Product consolidation D-SERIES DRI sockets

Modification of the RIM module connection point.

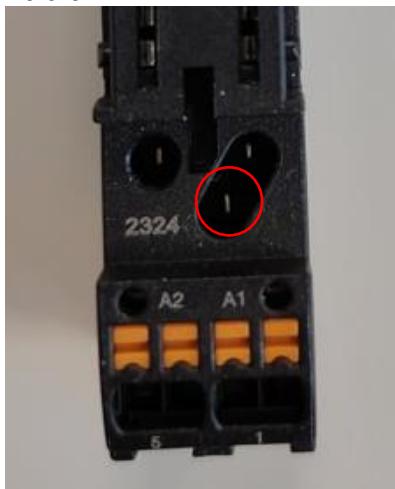
- Redesign of the connection port of the LED/ protection module

This change of the metal pin is to improve product quality.
